Our Ref.: 25/868/L08

**Temporary Market (Flea Market) and Eating Place for a Period of 3 Years in “Village Type Development” Zone and Area shown as “Road”, Lots 398(Part), 399SA(Part), 399RP(Part), 400 (Part) and Adjoining Government Land in DD109, Kam Sheung Road, Kam Tin, Yuen Long, New Territories (Application No.: A/YL-KTS/1091)**

**Table 1: Responses to Comments from Government Departments on Planning Application No. A/YL-KTS/1091 (18 March, 2026)**

Drainage Submission in support of

**PROPOSED ROOF DRAINAGE  
ARRANGEMENT PLAN**

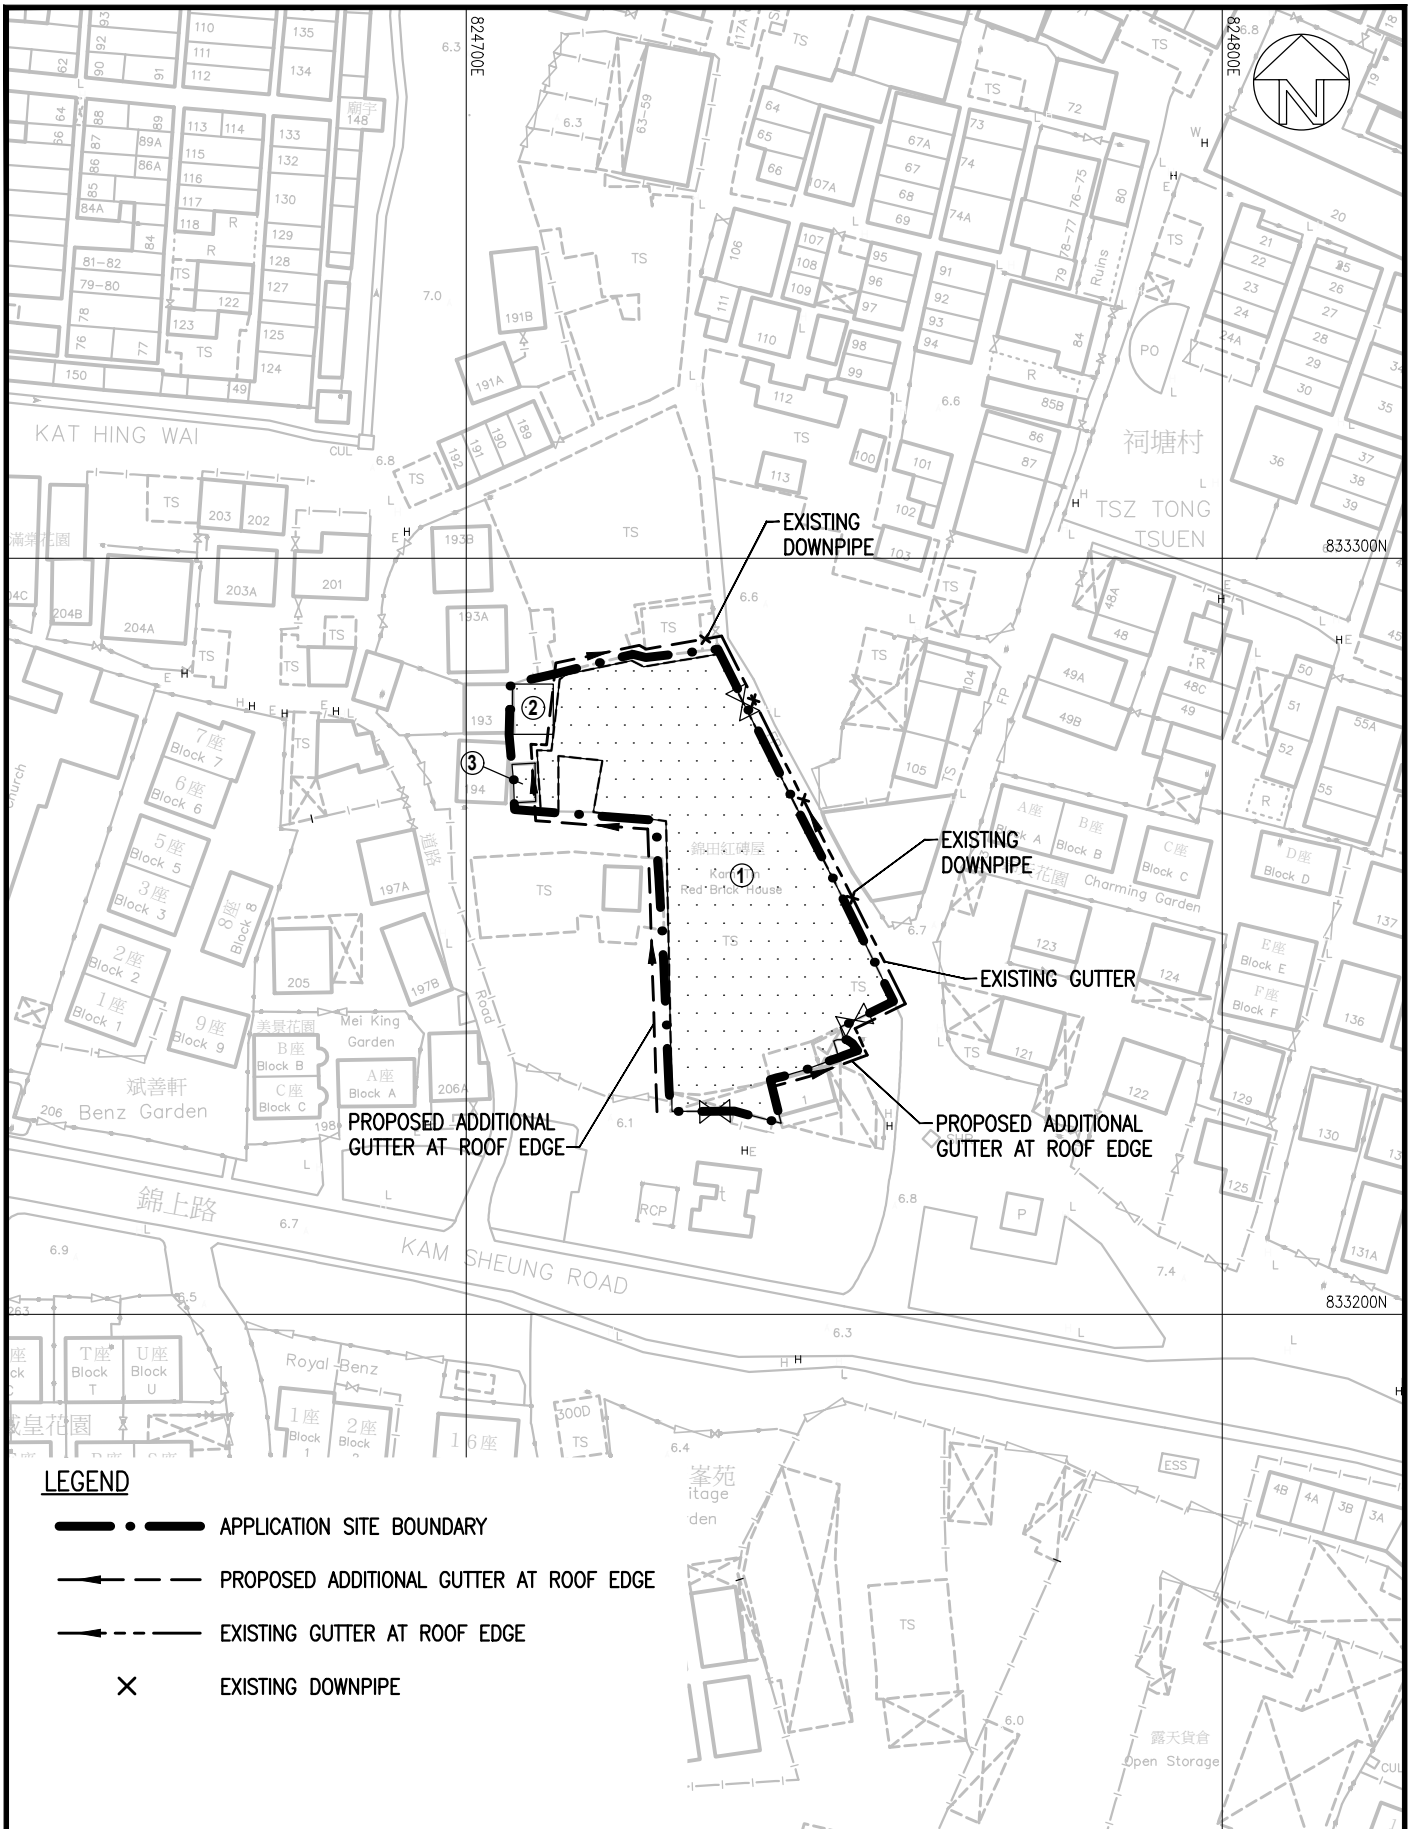
COMMENTS	RESPONSES
<b>Drainage Services Department (DSD)</b>	
<p>1. As compared with the agreed drainage proposal in previous planning application (A/YL-KTS/440) , the proposed 225mm peripheral surface channel located at the western side of the application site is missing in this submission. Please be reminded that peripheral surface channels shall be provided along the site boundary at the existing/original ground level (instead of the revised ground level) to collect the surface runoff accrued on the application site and to intercept the overland flow from the adjacent lands. Please make reference to the latest Technical Note No. 1 issued by DSD and provide adequate drainage facilities or upgrade the size and/or gradient of the existing drainage facilities accordingly.</p>	<p>Since the approval of the drainage proposal in the previous planning application No. A/YL-KTS/440, site conditions of the area outside the western boundary of the subject site were changed as late as year 2011 as indicated in the below aerial photos taken in 2011/2012 in which the area had already been paved and building structures had been erected at the western side of the subject site.</p> <div style="display: flex; justify-content: space-around; align-items: center;"> <div style="text-align: center;"> <p>Date: 12.12.2011</p>  <p>Aerial Photo No.: CW92901</p> </div> <div style="text-align: center;"> <p>Date: 10.9.2012</p>  <p>Aerial Photo No.: CS37789</p> </div> </div> <p>At present, a shelter is maintained within the open area along the western boundary of the application site as shown in the below recent site photo:</p>

COMMENTS	RESPONSES
	 <p>Surface water is prevented to flow toward the subject site. In order to prevent rainwater flowing from the roof of the existing structure within the application site onto the western area, peripheral gutter was therefore proposed to be installed at the edge of the roof of the building. All rainwater flowing across the boundary of the application site will then be intercepted by the peripheral channels and/or roof gutters of the application site.</p>
<p>2. Besides, please note that there is no public sewer connection available in the vicinity of the proposed development, views and comments from the Director of Environmental Protection should be sought regarding the sewage disposal arrangement of the proposed development. The sewerage generated from the application site should not be discharged into the existing public stormwater drainage system anytime.</p>	<p>Noted. The planning application was also vetted by the Director of Environmental Protection.</p>

4.6 The drainage concern is to avoid stormwater falling onto the roof of the building of the Application Site to fall directly onto the adjacent areas in particular along the western boundary of the Application Site. It is therefore proposed to install additional gutter at the edge of the roof of the building of the Application Site. The additional gutter will be connected to the downpipe to discharge into the channel as shown on **Plan 4**.
